TRUCK, CARGO, LIGHT, MC2 LANDROVER 110 - ALL TYPES 6x6

FUSING OF ADDITIONAL CIRCUITS

MODIFICATION INSTRUCTION

FIG 1 - FUSE COVER

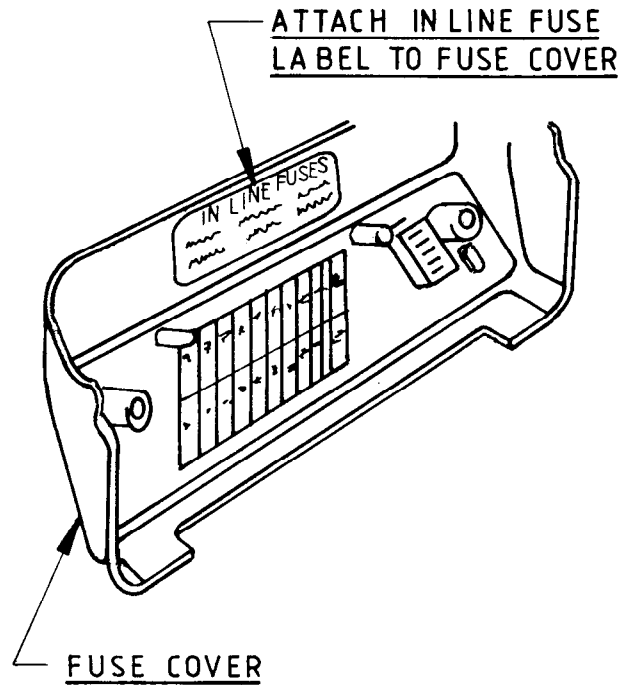
- h. Interlock the fuse holders with the cable tie (item 1 from Table 2).
 - i. Attach the label (item 5 from Table 1) to the inside surface of the fuse cover as shown in Fig 1.

FIG 2 - FFR LAMP

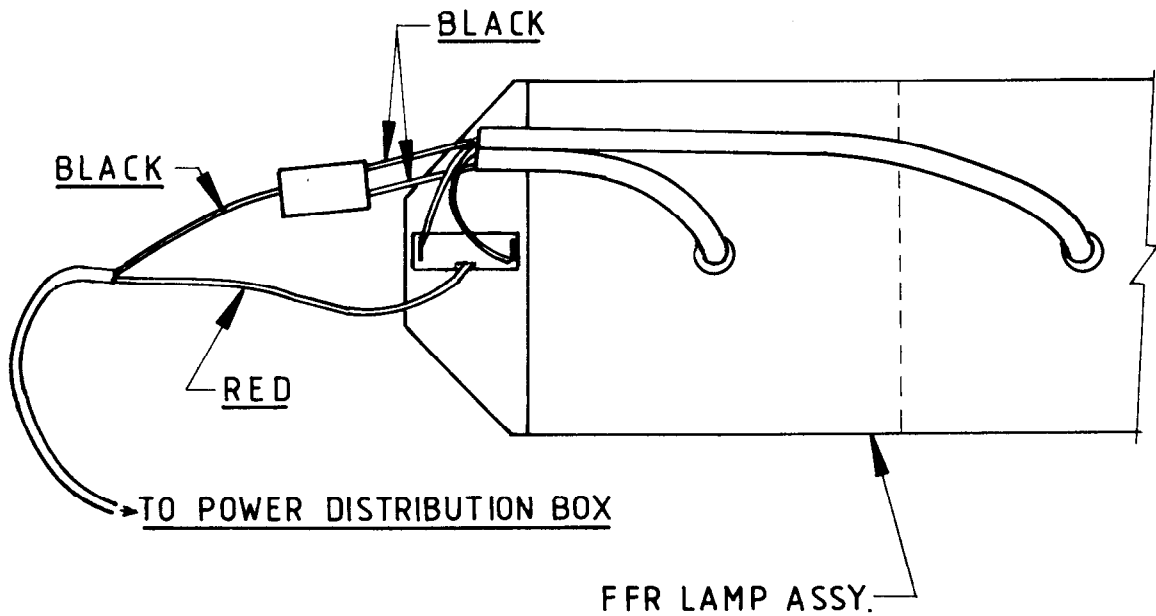
- k. Refit the mounting bracket and fascia plate to the dash.
- l. Reconnect the battery and check that the inspection socket and instrument dimmer switch function correctly.
- m. Refit the blackout and dimmer switch knobs and the ashtray.
- n. On FFR variants:
 - (1) Disconnect the radio batteries.
 - (2) Identify the red wire to the FFR lamp, as shown in Fig 2, cut the wire and fit the fuse holder and crimp terminals (item 6 from Table 1) to the wire.

(3) Fit a 5 amp fuse (item 7 from Table 1) to the holder and attach the holder to the loom with a cable tie (item 1 from Table 2).
